Conceptual Review Agenda

Schedule for 11/07/16 to 11/07/16

Monday, November 7, 2016

Stanton Creek 3rd Filing Replat

PROPOSED SITE PLAN
 SCALE: 1" = 20'-0"

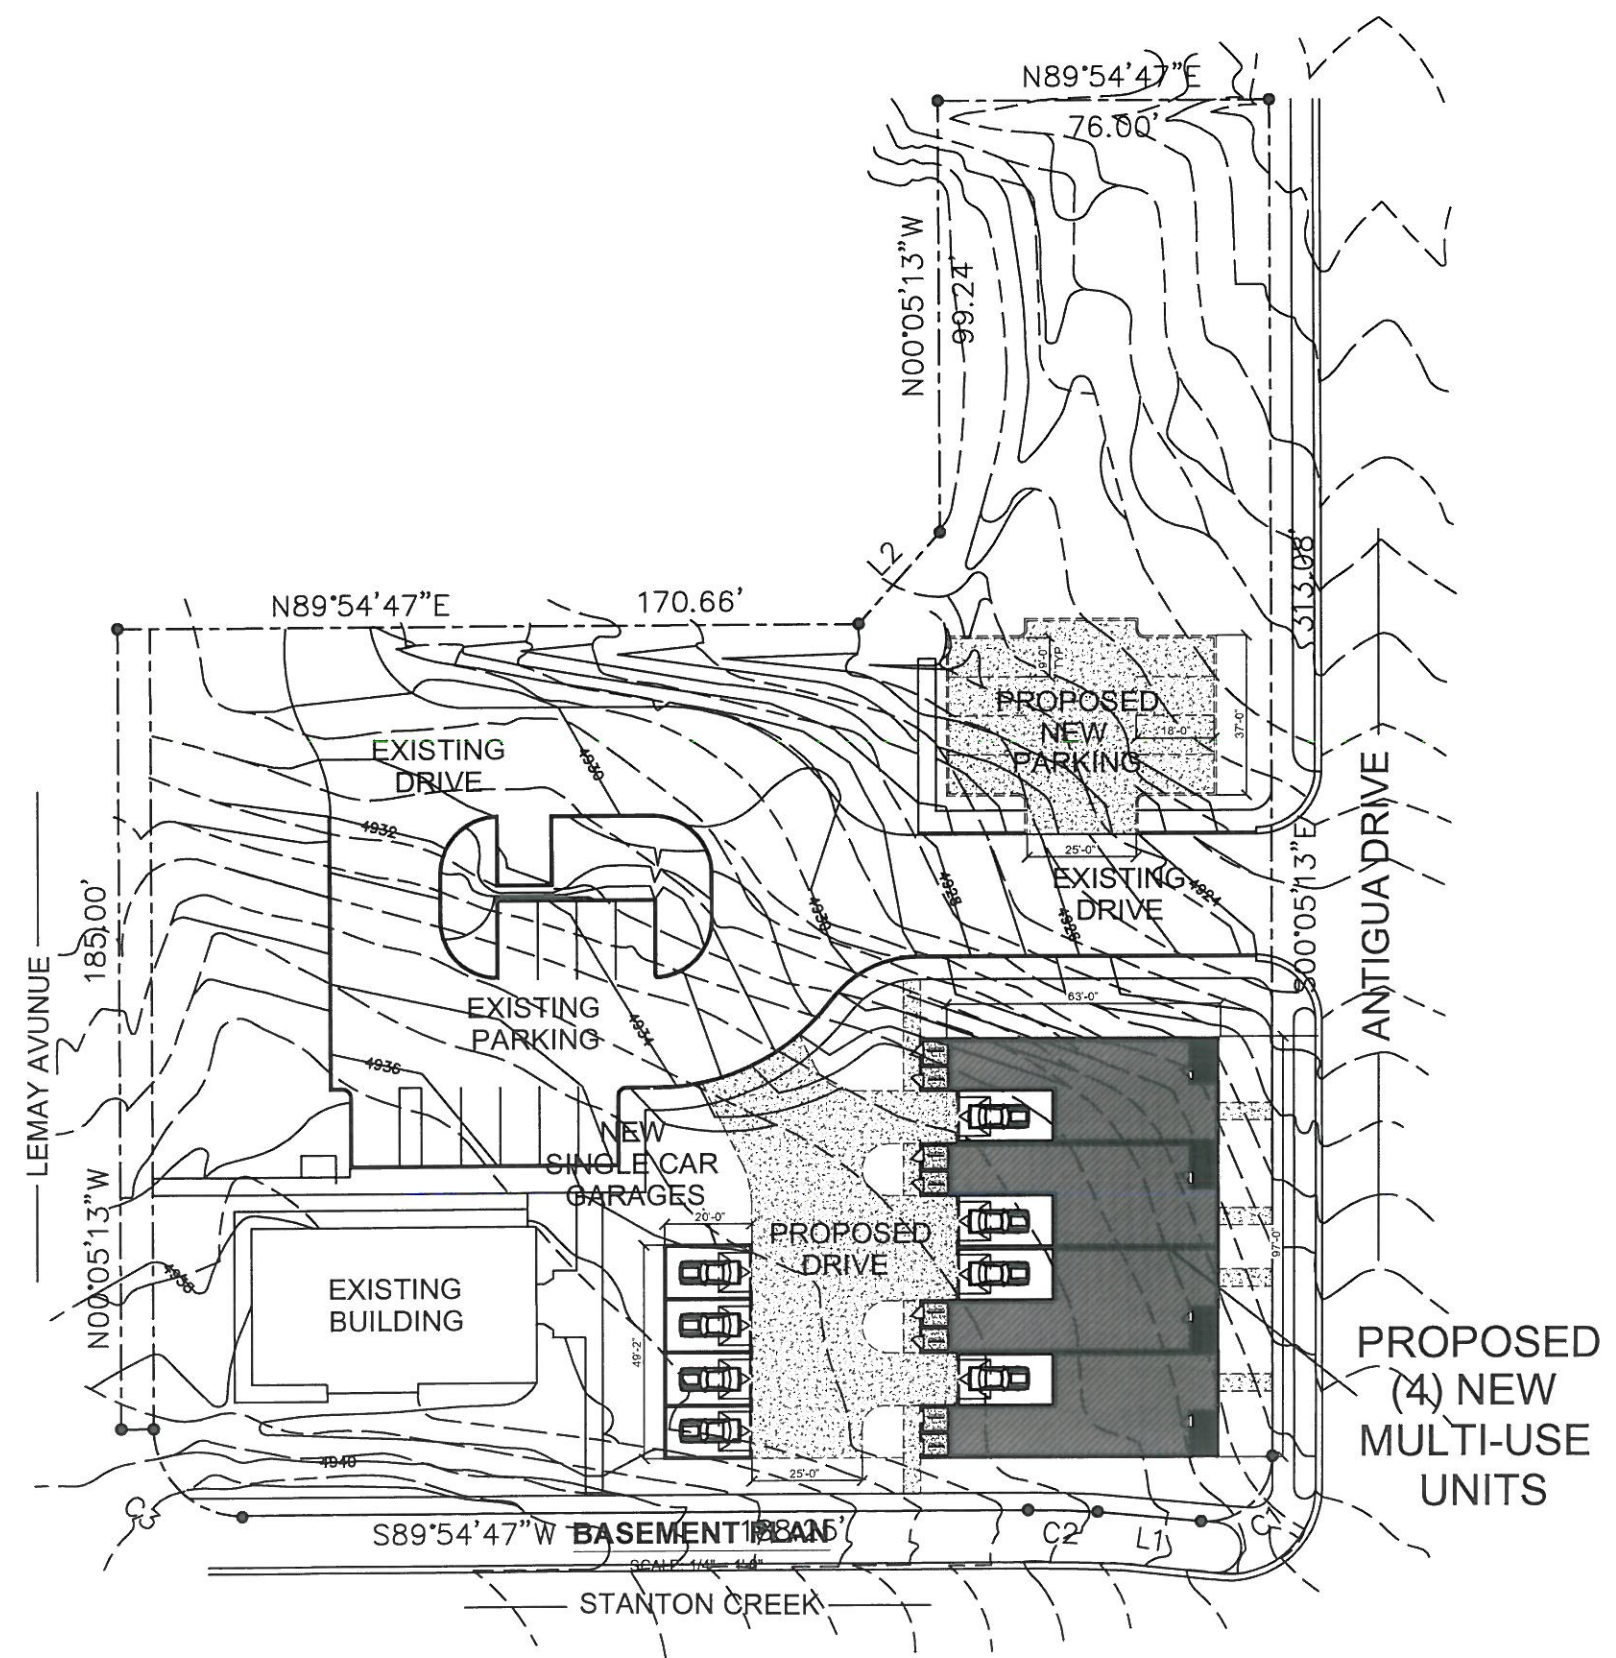
1. In order to be considered mixed-use dwellings these must include a nonresidential use. What kinds of uses are you proposing?
2. There will be parking requirements based on the commercial use square footages. As well as handicap parking requirements.
3. Bike parking will be required for the residential units and commercial uses.
4. LUC 3.2.5 All development shall provide adequately sized conveniently located, accessible trash and recycling enclosures.
5. A landscape plan will be required.

A question: is the purpose of the replat to subdivide, or simply to change the existing approved building envelope?
